Office Action Summary

10/765,636

SAVICKI ET AL

DETAILED ACTION

FIG. 5

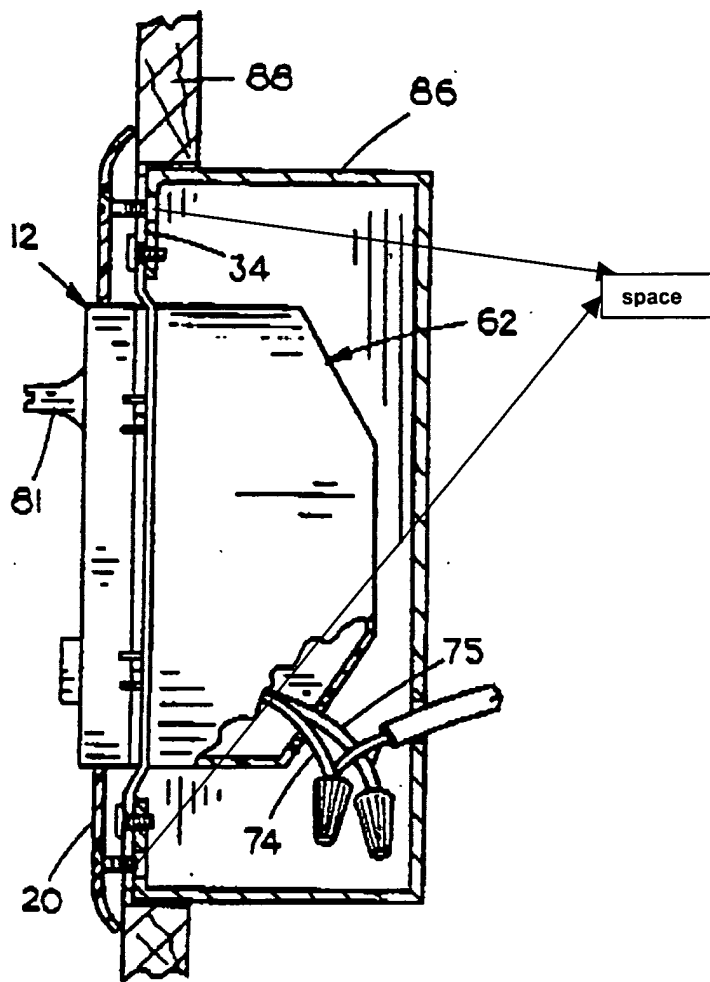
- a switch body 1 including switch contact (see attachment);
- a frame 5 attached to the switch body;
- a paddle 6 for actuating the switch contacts;
- wherein the paddle has a pivot structure cooperatively engageable with a portion of the frame for selective rotational movement around a pivot axis (see the attachment) between a limited forwardly-tilted position and a limited rearwardly-tilted position;
- wherein the paddle has a uni-convex cylindrical exterior surface with a curvature, R_p (see the attachment);
- the paddle 6 has an actuating structure integrally attached to a rear surface thereof having a distal end that operationally enables an open-switch condition and a closed-switch condition;
- the paddle 6 has an upper and a lower circumferential surface (see the attachment) each having a curvature, R_b , the center of which originates along the pivot axis;

Yei further comprises the paddle 6 includes an upper and a lower circumferential surface having a curvature, R_b (see the attachment), the center of which originates along the pivot axis.

- one of the upper and the lower circumferential surfaces 20 engages a space (see the attachment) intermediate a portion of the mounting strap 34 and a surface of the frame 86 in one of the forwardly-tilted position and the rearwardly-tilted position;
